Subject: AP1000 Response to Request for Additional Information (SRP 3)

RAI-SRP3.9.4-EMB1-01 R2

# AP1000 TECHNICAL REPORT REVIEW

RAI Response Number: RAI-SRP3.9.4-EMB1-01

Figure 3.9-4  
Control Rod Drive Mechanism

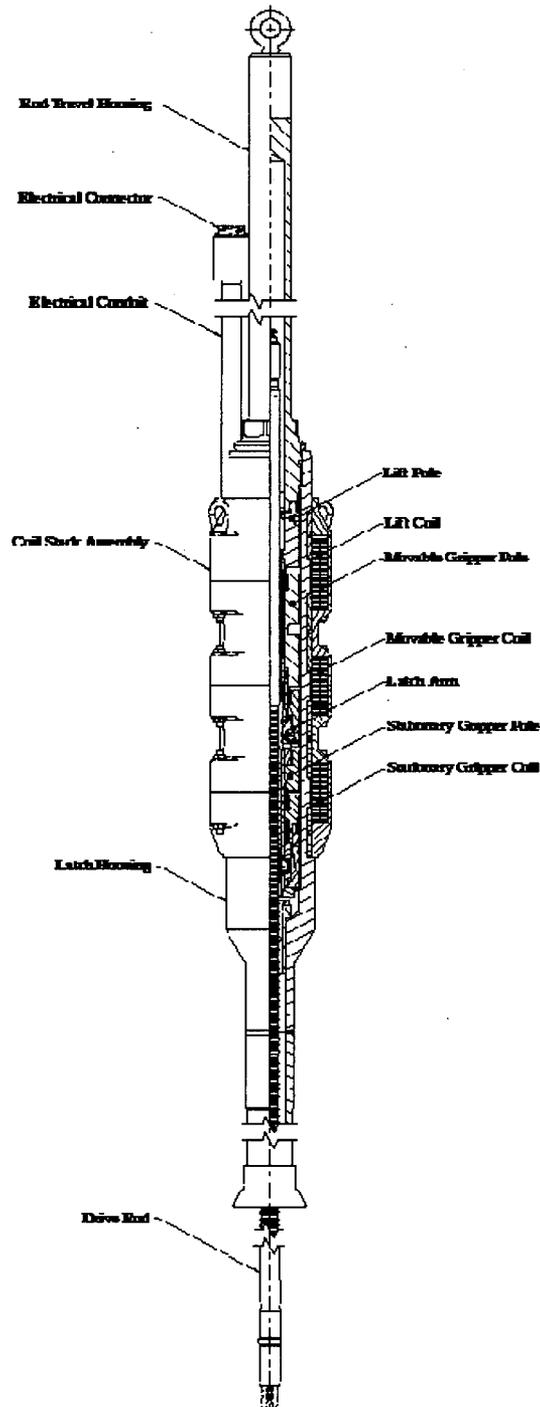
During the review of the Design Control Document for information that needs to be changed to address this request for additional information, changes to CRDM design information including the figure and materials was noted and is provided below.

Replace Tier 2 Figure 3.9-4 with the figure shown below.
